# Access Compliance Report

## Public Rights-of-Way

Intersection ID: 10038838	Main Street: STEELECROFT_PY	Cross Street: N/A	Location: SW
ADA ID: 8910D7F4414A	Ramp Type: PerpDiag	Initial Pass/Fail: Fail	Overall Compliance: No
Severity Score: 8.75			
Codes/Mitigation Info/Possible Solution		Field Measurements/Component Compliance

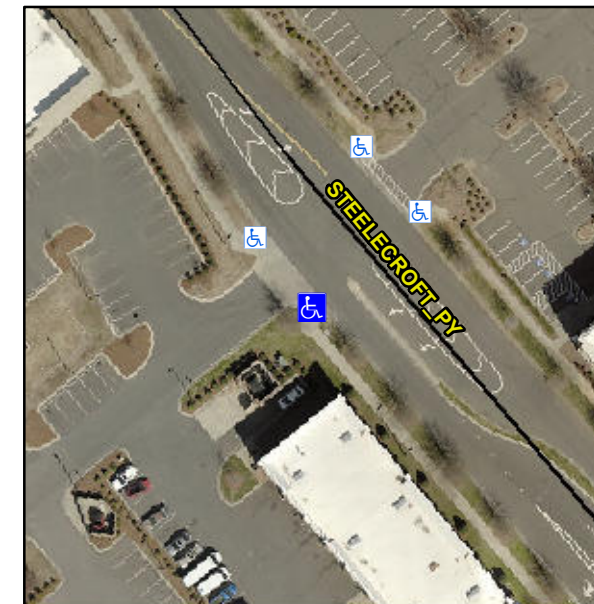
**Not Found, R304.5.1**

Compliance	Description	Data	Compliance	Description	Data
N/A	Ramp Length (in)	101.0	Yes	Ramp Slope (%)	7.5
No	Ramp Width (in)	42.0	Yes	Ramp XSlope (%)	1.9
N/A	Flare Type LT	N/A	N/A	Flare Type RT	N/A
N/A	Flare Slope LT (%)	N/A	N/A	Flare Slope RT (%)	N/A
N/A	Flare Traversable LT?	N/A	N/A	Flare Traversable RT?	N/A
N/A	Landing Length (in)	N/A	N/A	DWS Provided?	N/A
N/A	Landing Width (in)	N/A	N/A	DWS Contrast?	N/A
N/A	Landing Slope (%)	N/A	N/A	DWS Length (in)	N/A
N/A	Landing X Slope (%)	N/A	N/A	DWS Full Width?	N/A
N/A	Landing Curb? (Y/N)	N/A	N/A	DWS Offset (in)	N/A
N/A	Shared Landing?	N/A			
N/A	Gutter Ponding?	N/A	N/A	Gutter Slope (%)	N/A
N/A	Gutter Lip Ht (in)	N/A	N/A	Gutter X Slope (%)	N/A
N/A	Painted X Walk1?	No	N/A	Painted X Walk2?	No
	X Walk 1 Direction	To NE		X Walk 2 Direction	To NW
N/A	X Walk 1 Width (in)	N/A	N/A	X Walk 2 Width (in)	N/A
	X Walk 1 Slope (%)	2.3		X Walk 2 Slope (%)	0.4
	X Walk 1 X Slope (%)	2.1		X Walk 2 X Slope (%)	2.2

**Remove & Replace Curb Ramp With Two New Directional Ramps or Equivalent.**
